**SINCLAIR CENTRE
REVITALIZATION PROJECT
757 W HASTING ST. VANCOUVER**

**SECTION 10 AND X - X REVISED
(XREF. DWG. S313)**

**SINCLAIR CENTRE
 REVITALIZATION - PHASE 2**

Revision/	Description/Description	Date/Date
2	ISSUED FOR MECHANICAL ADDENDUM #2	2013/06/12
1	ISSUED FOR MECHANICAL ADDENDUM #1	2013/06/04
0	ISSUED FOR TENDER	2013/04/24
Client/client

1 HYDRONIC - PASSPORT OFFICE - LEVEL B1
M1.04 SCALE: 1:100

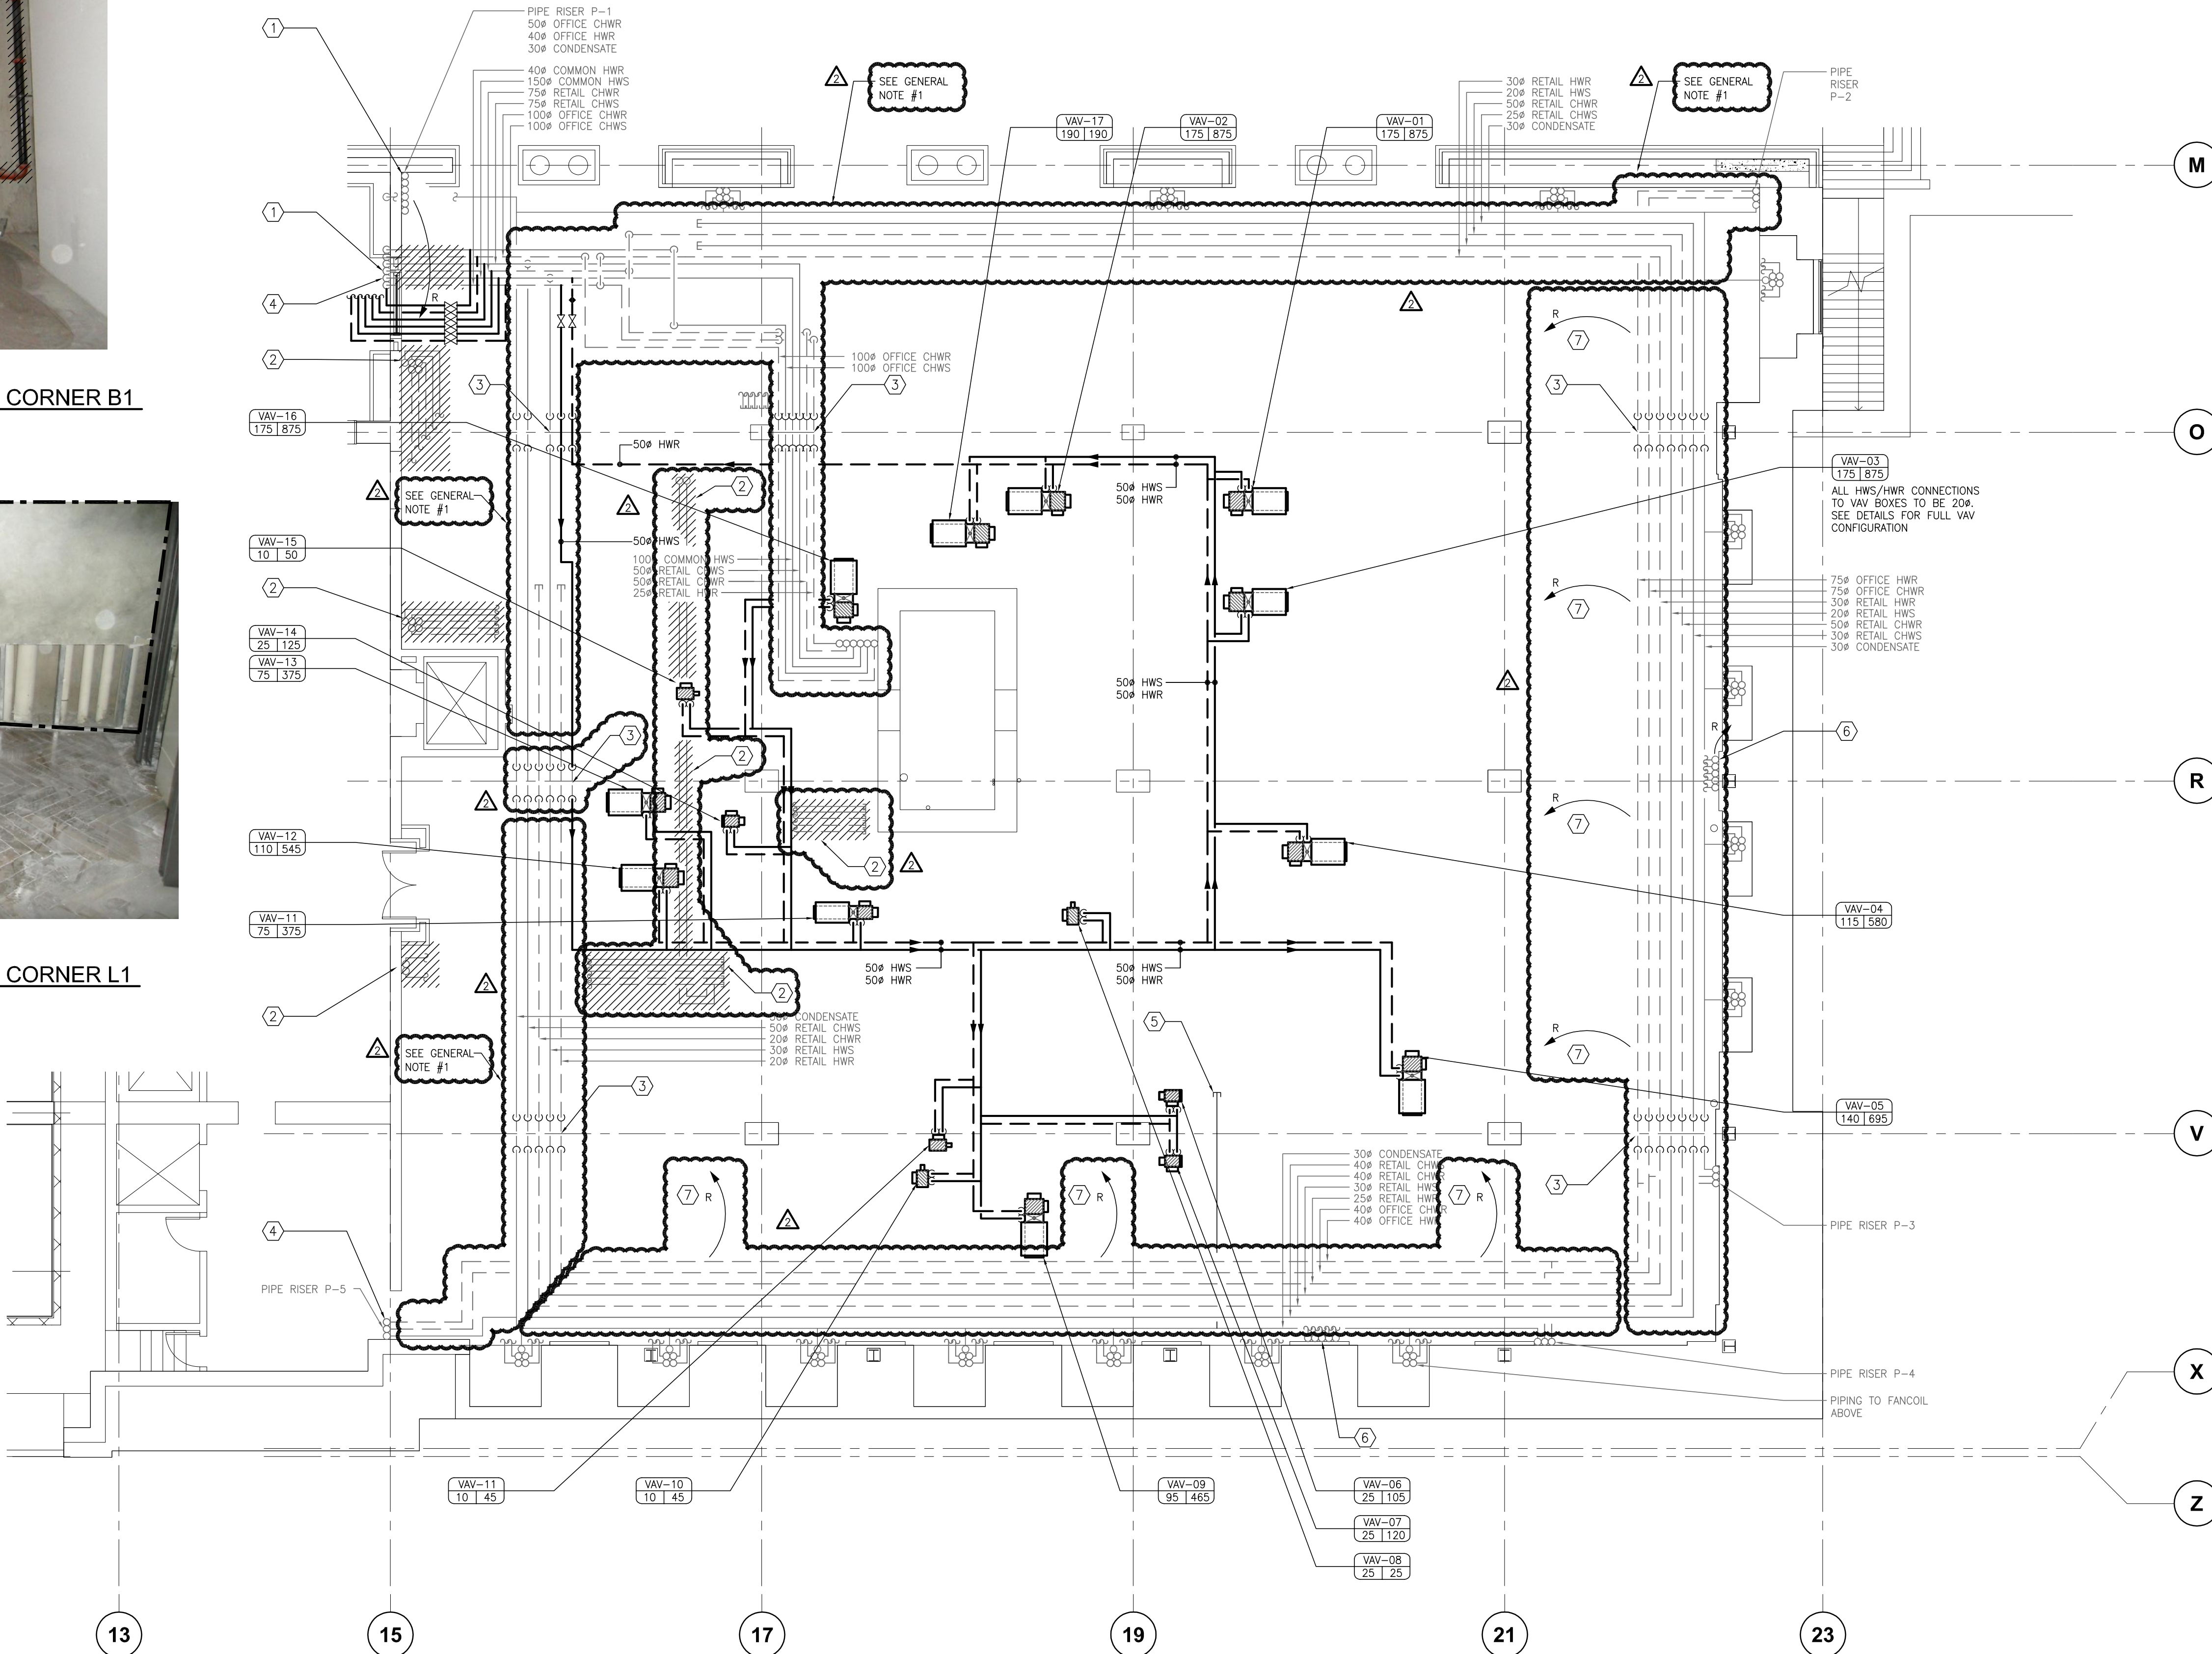
- CONTRACTOR TO ALLOW FOR DIVERTING ENTIRE NETWORK OF EXISTING PIPING (HYDRONIC, PLUMBING, ETC.) APPROXIMATELY 300MM LOWER THAN EXISTING (EXACT HEIGHT TO BE DETERMINED ON SITE) TO ALLOW FOR NEW STRUCTURAL UPGRADES, WHICH INCLUDE NEW DIAGONAL CROSS-BRACING BELOW STRUCTURAL RIBS. ALLOW FOR RE-CONNECTION TO ALL RISERS, FANCOILS, ETC.
- REFER TO STRUCTURAL DRAWINGS FOR NEW SEISMIC UPGRADES, INCLUDING NEW 600MM SEISMIC WALL ALONG GRIDLINE 15 AND DRAG STRUTS ALONG GRIDLINES O AND V. EXISTING HYDRONIC LINES, RISERS, AND CONNECTIONS TO FANCOILS ABOVE MUST BE OFFSET, RE-LOCATED, OR DISCONNECTED AND CAPPED TO ACCOMMODATE THESE UPGRADES.
- REFER TO DRAWINGS M1.02, M1.03 AND M1.06 FOR ADDITIONAL INFORMATION ON PLUMBING, FIRE PROTECTION AND HVAC IN THIS AREA.

- RE-LOCATE PIPE RISER P-1 (ALLOW FOR SIX(6) 50# WELDED, INSULATED PIPES), AND DIVERT ALL MAINS (ASSUME 10M OF 150# WELDED PIPE AND EIGHT (8) ELBOWS) TO SOUTH TO ALLOW FOR NEW SEISMIC UPGRADES. OFFSET RISER AND ALL PIPING AGAINST WALL FOR 3M ON FLOOR ABOVE. SLEEVE PIPING THROUGH NEW WALL AS REQUIRED. SEE IMAGES 1 AND 2. PROVIDE NEW ISOLATION VALES ON EACH LINE ON LEVELS B1 AND B2. LOCATIONS TO BE COORDINATED ON SITE.

- DEMO FANCOIL ON FLOOR ABOVE AS WELL AS EXISTING FANCOIL PIPING TO ABOVE AND CAP OFF. ENSURE ADEQUATE ROOM IS AVAILABLE FOR NEW SEISMIC UPGRADES.
- OFFSET OF HYDRONIC LINES AS REQUIRED TO ACCOMMODATE NEW SEISMIC DRAG STRUT.

- INSTALL PIPE SLEEVES AROUND EXISTING SERVICES, PRIOR TO NEW CONCRETE WALL INSTALLATION.
- INSTALL NEW 25# CONDENSATE LINE FOR FUTURE SPACE ABOVE, CONNECT TO EXISTING

- RE-LOCATE HWS/R, CHWS/R, CONDENSATE RISERS TO FANCOILS ABOVE TO WINDOW BAYS TO ALLOW FOR NEW CONCRETE. SEE STRUCTURAL/ARCHITECTURAL DWGS.

CONTRACTOR TO ALLOW FOR RE-LOCATION OF 30# COND, 40# RETAIL CHWS/R, 30# RETAIL HWS, 25# RETAIL HWR, 40# OFFICE CHWR, 40# OFFICE HWR LINES AWAY FROM SOUTH AND EAST WALLS TO ACCOMMODATE INSTALLATION OF NEW STRUCTURAL BEAM AT HIGH ELEVATION ALONG THE ENTIRE SOUTH AND EAST WALLS (ALONG GRIDLINES X AND Z). COORDINATE WITH DIVERTING OF ALL PIPES IN GENERAL NOTE 1 ABOVE AND REFER TO STRUCTURAL DRAWINGS FOR MORE INFORMATION

KITCHEN HVAC PLAN

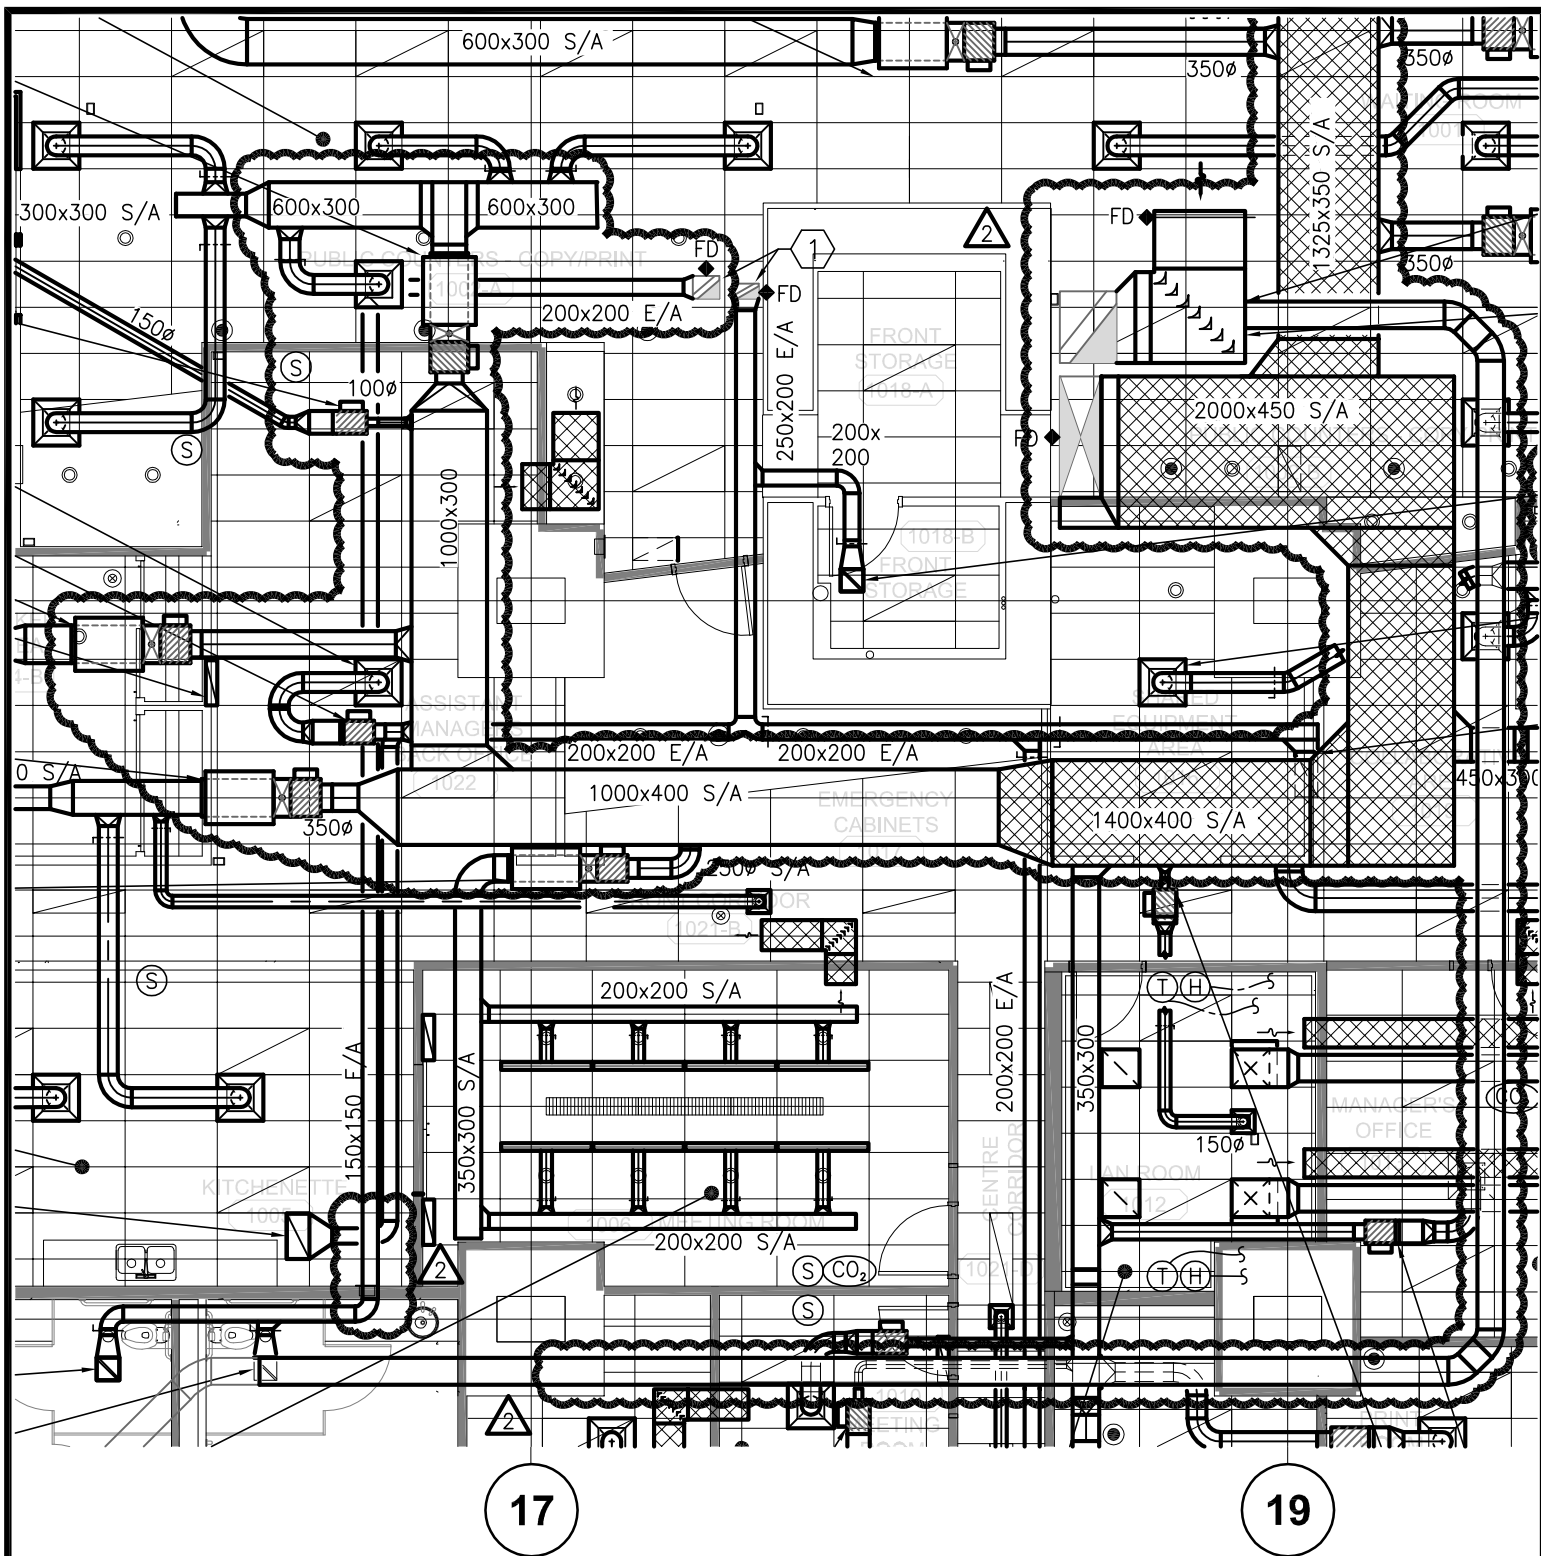
- 3 PENETRATIONS OF NEW FIRE-WRAPPED KITCHEN EXHAUST DUCTWORK THROUGH NEW FIRE-RATED R/A BOOT TO MAINTAIN CONTINUOUS FIRE-RATING.
- 4 INSTALLATION OF NEW KITCHEN EXHAUST DUCTWORK TO BE IN FULL COMPLIANCE WITH NFPA 96 (ACCESS PANELS, CLEANOUTS, ETC).

- 5 INSTALL NEW KITCHEN EXHAUST DUCTWORK INSIDE EXISTING SHAFT RISER. PROVIDE ACCESS PANELS AND CLEANOUTS ON EACH FLOOR. PLEASE NOTE THAT CONTRACTOR SHOULD ALLOW FOR ACCESS PANELS THROUGH FIRE-RATED SHAFT, AND CLEANOUTS FOR THE NEW KITCHEN EXHAUST DUCTWORK ON EACH FLOOR.

- 6 EXISTING KITCHEN EXHAUST FIRE-RATED RISER TO BE CONVERTED TO GENERAL EXHAUST PLENUM AND ALSO USED AS SHAFT FOR NEW KITCHEN EXHAUST DUCTWORK. EXISTING KITCHEN DUCTWORK IS TO BE COMPLETELY DEMOLISHED PRIOR TO INSTALLATION OF NEW.

- 7 RUN NEW KITCHEN EXHAUST DUCT INSIDE GENERAL EXHAUST FIRE-RATED SHAFT UP TO ROOF KITCHEN EXHAUST UPBLAST FAN (FULLY-WELDED PENETRATIONS OF NEW KITCHEN EXHAUST DUCT THROUGH GENERAL EXHAUST DUCT WITHIN PENTHOUSE MECHANICAL ROOM.

RUN NEW 350X250 DUCT ALONG GRIDLINE V ONCE EXISTING IS DEMOLISHED (SEE M1.06)
